Cottonwood Springs Replat A

City of El Paso — City Plan Commission — 2/21/2019

SUSU19-00004 — Resubdivision Combination Applicant requested to postpone 4 weeks

ATTACHMENT 5

ATTACHMENT 2

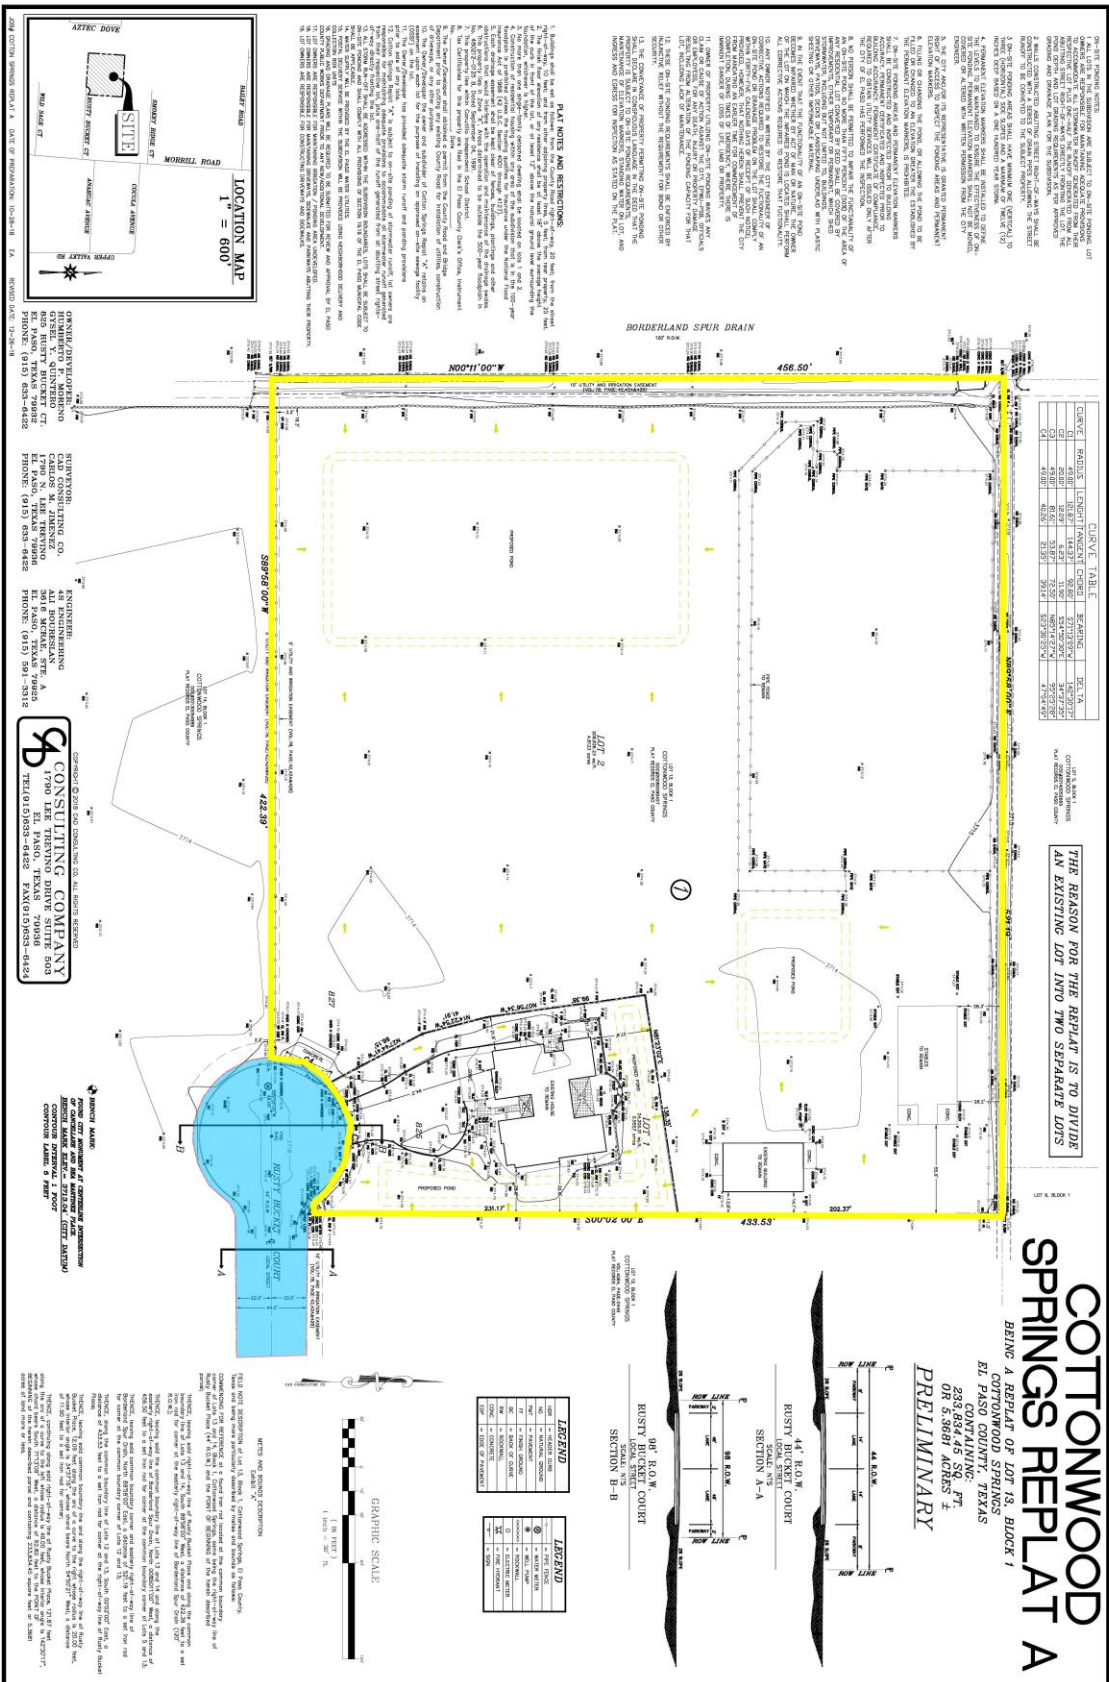
- 1. Show existing and proposed drainage flow pattern arrows on the preliminary plat and identify the discharge pond location(s) for all storm water runoff or a typical lot storm-water runoff detail. No drainage calculations nor details needed at this time.

- 2. Show proposed drainage flow pattern for lot 1.
- 3. Provide the Federal Emergency Management Agency (FEMA) Flood Insurance Rate Map (FIRM) panel information on the preliminary & filing plat.

- 4. The elevation marker shown on the detail needs to be modified: the marker needs to extend one foot above the ground (DSC 2-7).
- 5. At the improvement plan stage, protect the subject property from storm-water runoff from the adjacent terrain.

- 6. The street cross-section for Rusty Bucket Ct. should show slope and direction.
- 7. Coordinate with The Water Improvement District #1 for any improvements or modifications affecting abutting irrigation ditches.
